DEVELOPMENT APPLICATION ASSESSMENT REPORT

FILE No.	DA528/2016/1
ADDRESS	13, 13A, 15 and 15A Coolong Road Vacluse
ZONING	R2 Low Density Residential
PROPOSAL	The construction of a dwelling-house, swimming pool, ancillary structures, landscaping and siteworks
COST OF WORKS	\$10,128,095
DATE LODGED	30/11/2016 (original), 09/06/2017 (additional information)
APPLICANT	Corona Projects Pty Ltd
OWNER	Mr L Kamenev
AUTHOR	Mr D Booth
TEAM LEADER	Ms E Smith
SUBMISSIONS	Six
RECOMMENDATION	Conditional approval

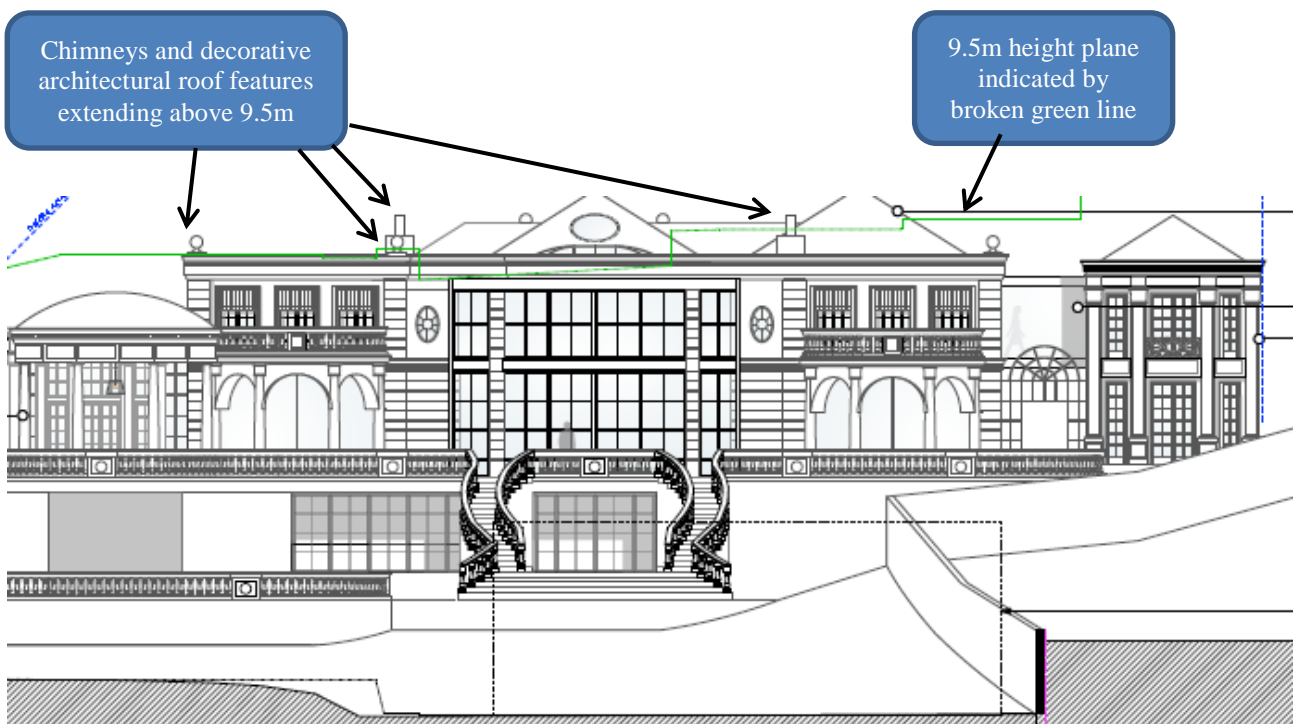
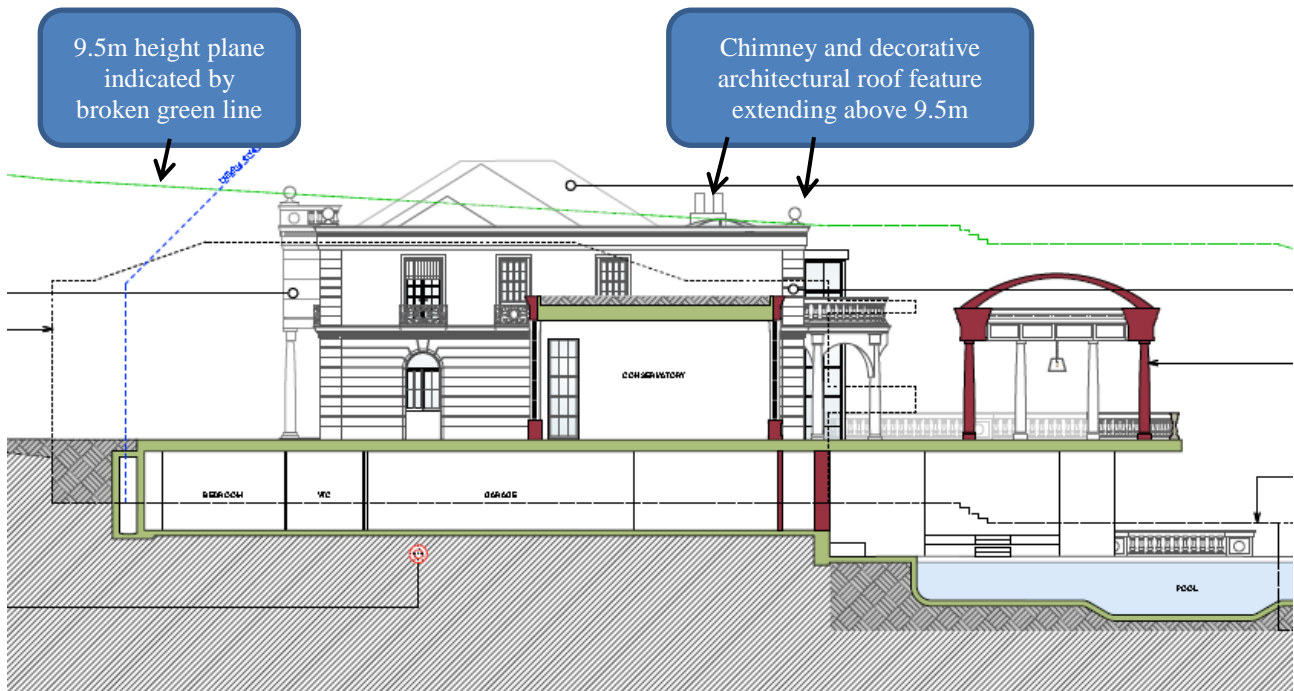
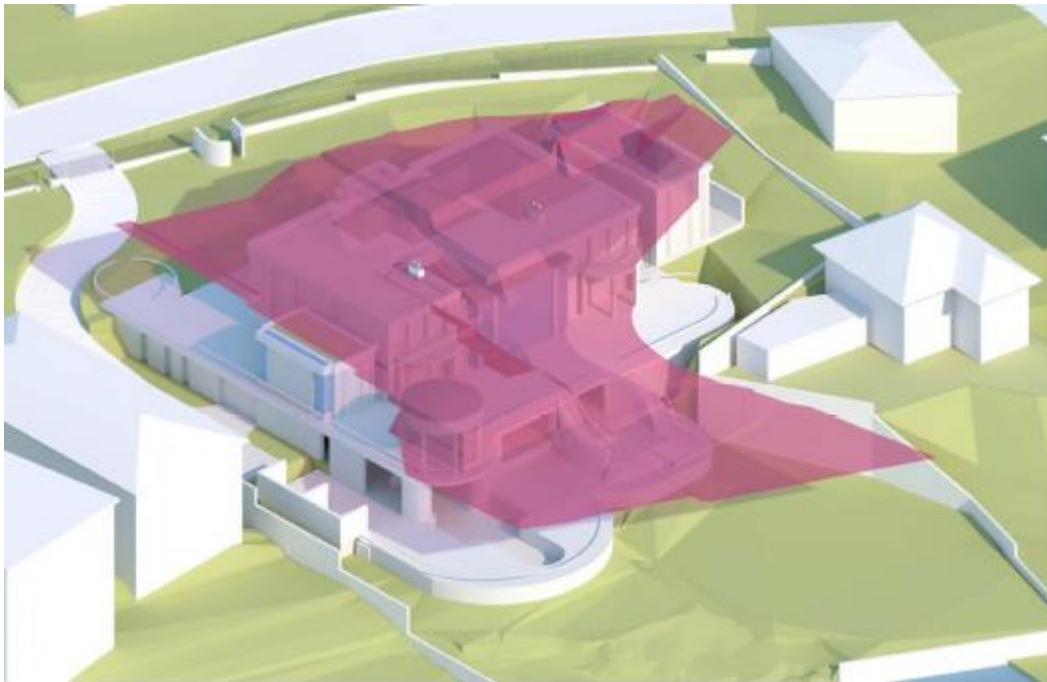
Two proposed chimneys and 2 decorative architectural roof features extend above Council's 9.5m height plane.

Concerns have been raised by objectors to the proposal that it involves breaches of Council’s 9.5m height development standard. In this regard, 2 proposed chimneys and 2 decorative architectural roof features extend above the 9.5m height plane as indicated in the diagrams below.

The image below indicates 2 chimneys protruding above the 9.5 m high plane but not the 2 decorative architectural roof features.

Whilst chimneys are expressly excluded from the following definition of *building height*, it is considered that sufficient doubt exists that the decorative architectural roof features are excluded to warrant their deletion in the absence of a Clause 4.6 written statement to vary the development standard. The uncertainty is based upon the fact that all of the excluded elements have a practical function whereas the subject non-compliant decorative architectural roof features are purely aesthetic. Accordingly, it is recommended that they be deleted. In order to prevent any consequential architectural disharmony, it is considered that all of the remaining decorative architectural roof features should be deleted (see recommended **Condition C.1c**).

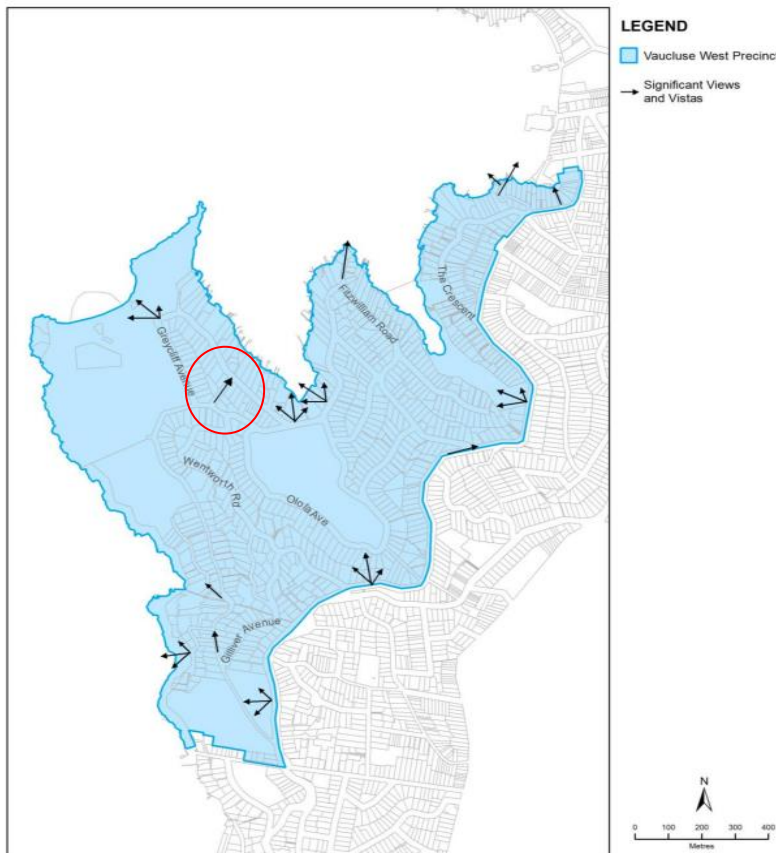
The proposed building on the amalgamated site will block views of the harbour that are currently seen through view corridors between buildings. This view down Nurran Road to the north-east is identified on the precinct map as a significant view (refer to MAP 10 from Woollahra DCP 2015 below - the circle has been added.
